Arboricultural Impact Assessment Report & Tree Management specifications

2 Lampard Road, Drouin

Prepared for Housing Choices Australia

Tree Logic Ref. 013416

Drawing Title	GROUND FLOOR OVERALL DRAINAGE PLAN
Project No.	AU250718
Drawing No.	C300
Revision	P08

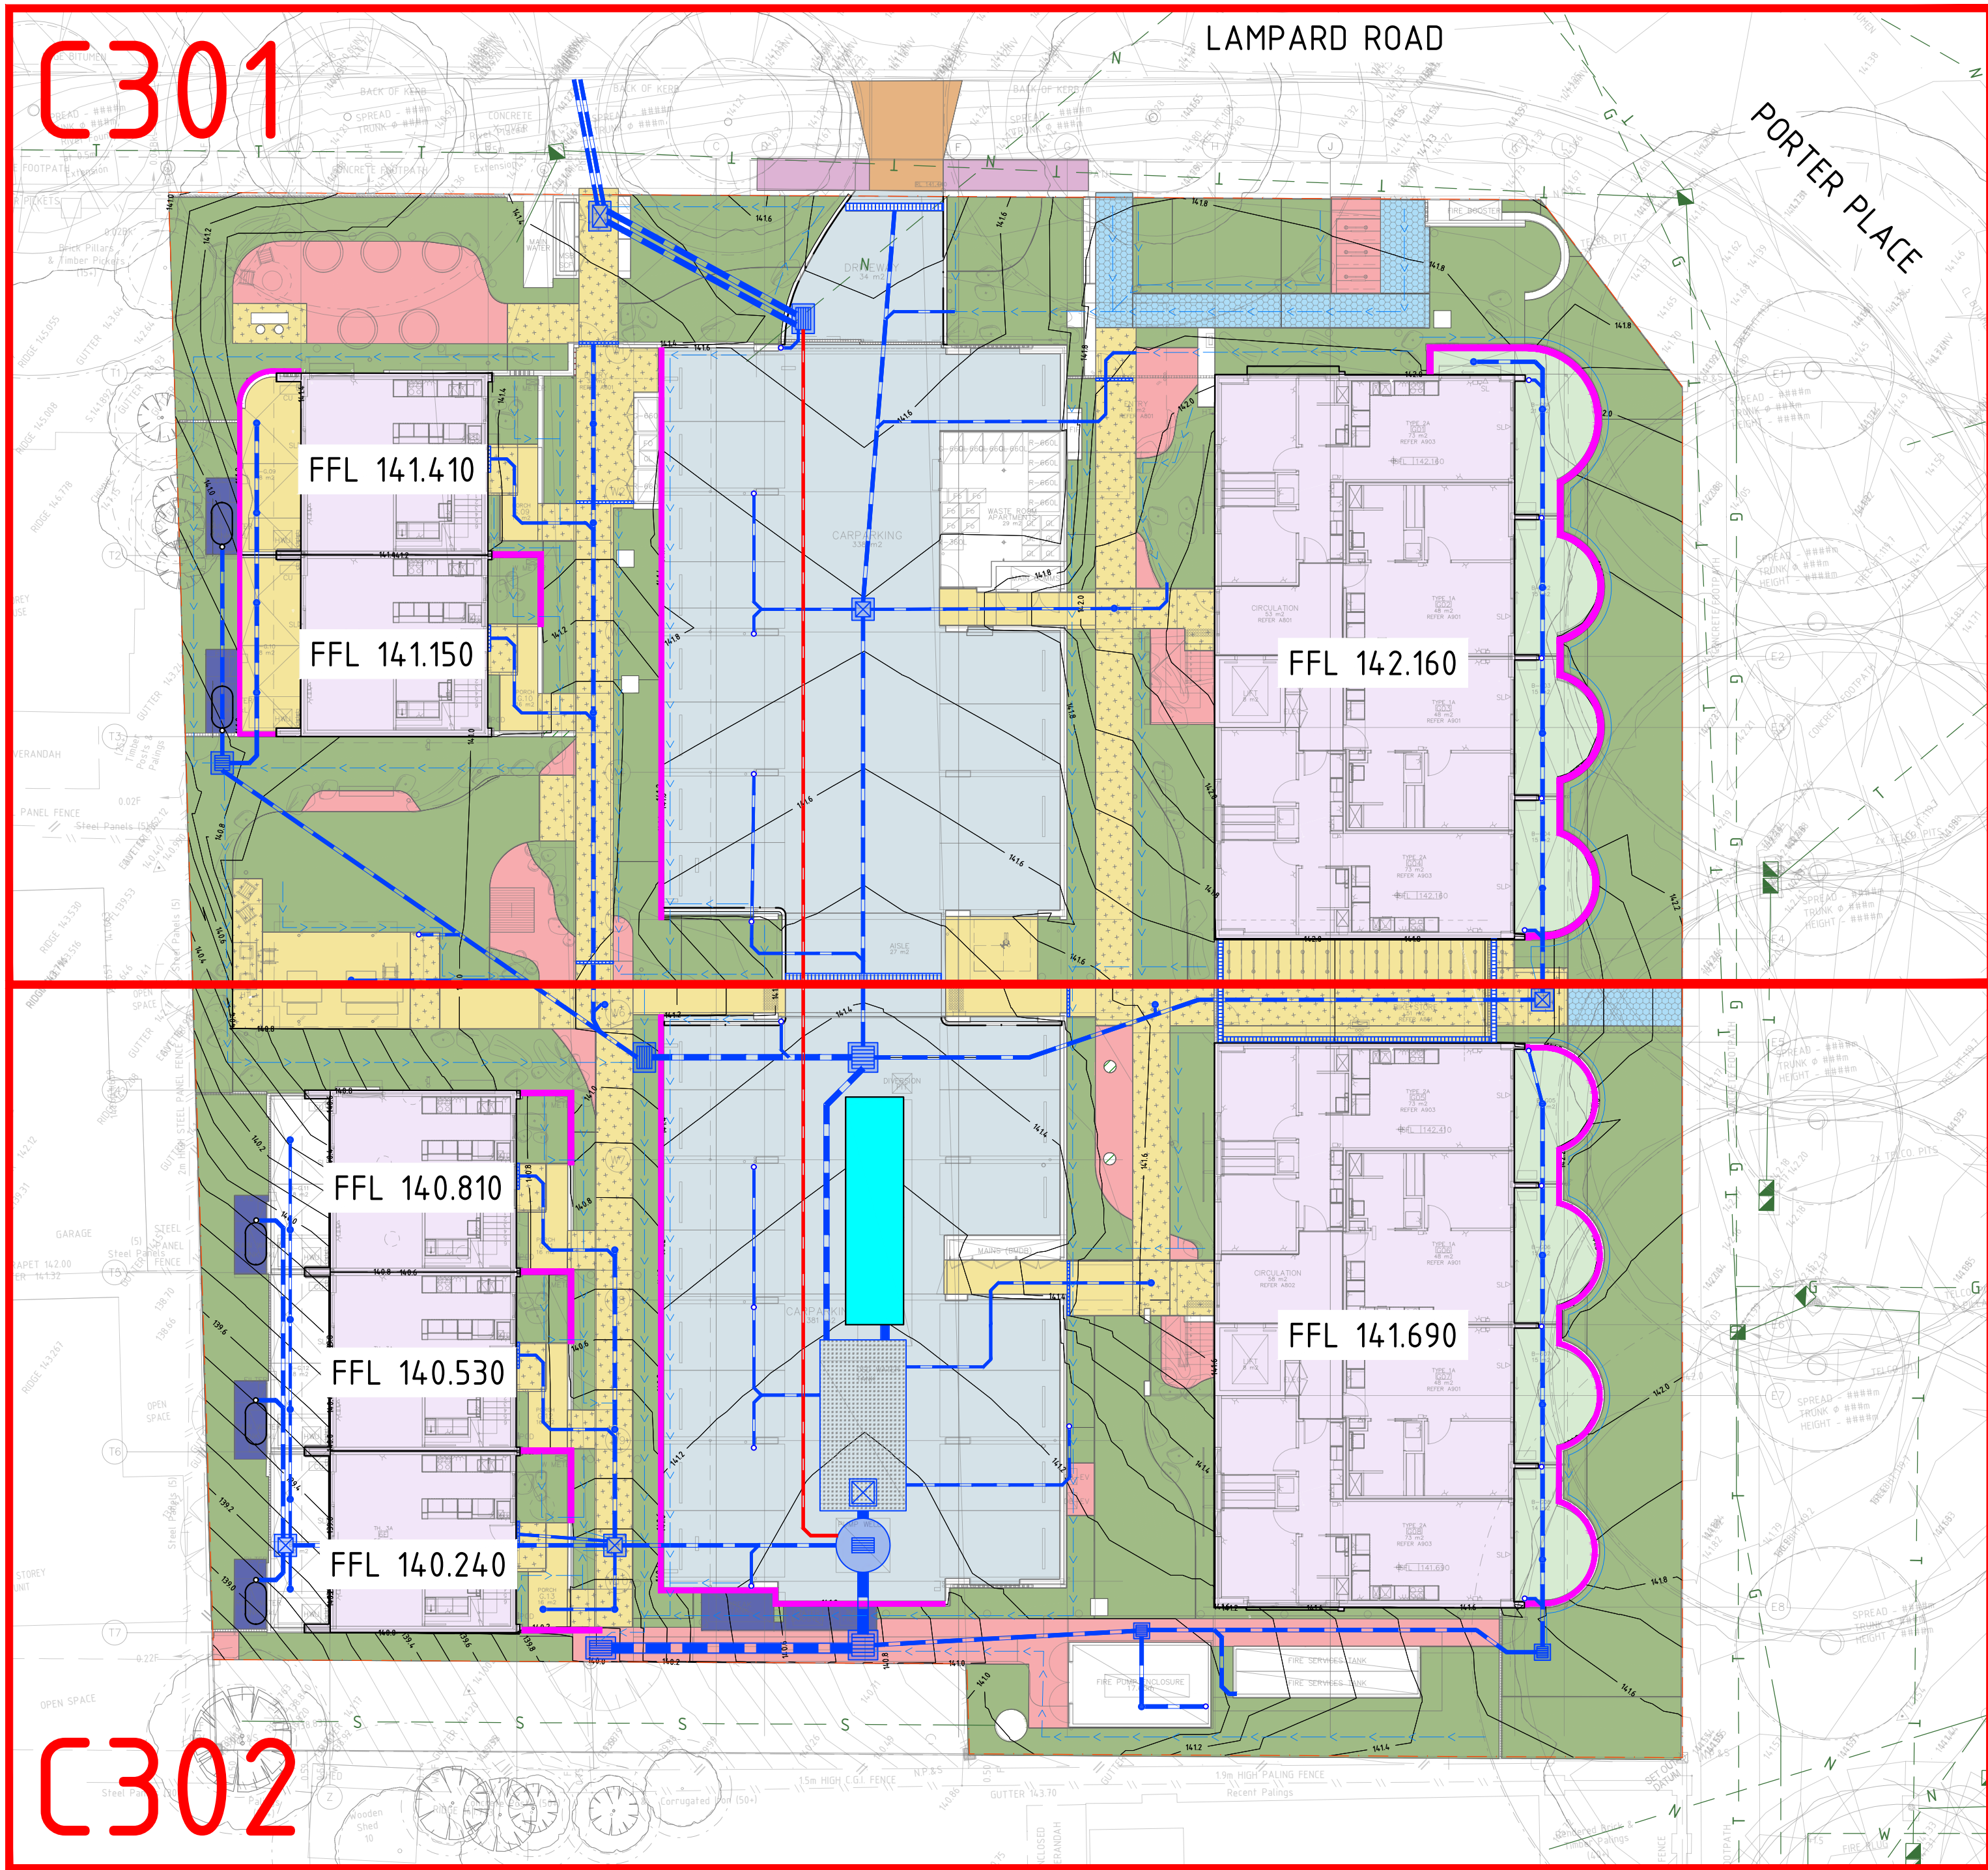
- 4.9 The drainage plan indicates that all stormwater pipes, pits and retention tanks are located outside of the NRZ of the retained street trees.
- 4.9.1 The LPD has been located between Trees 9 and 10 where the existing concrete crossover will be demolished and returned to grassed naturestrip.

- 4.11 The Water Metres and Storm Water discharge are indicated to be located between the TPZs of Tree 9 and 10 to avoid impacting these trees.
- 4.11.1 All connecting water mains must be either directed away from the TPZs of these trees or must be bored to the location of the metres at a depth of more than 650mm to the top of the bore head.

- TPZ exclusion fencing must be established between the edge of works and the back of the pedestrian footpath on Lampard Road.
- 4.12 Under the current design all other trees within 4-6 Lampard Road (Trees 12-35, 41-44, 50, 51 and Groups 1 and 2) are indicated to be removed and new trees introduced in the new landscape upon completion of the building works.
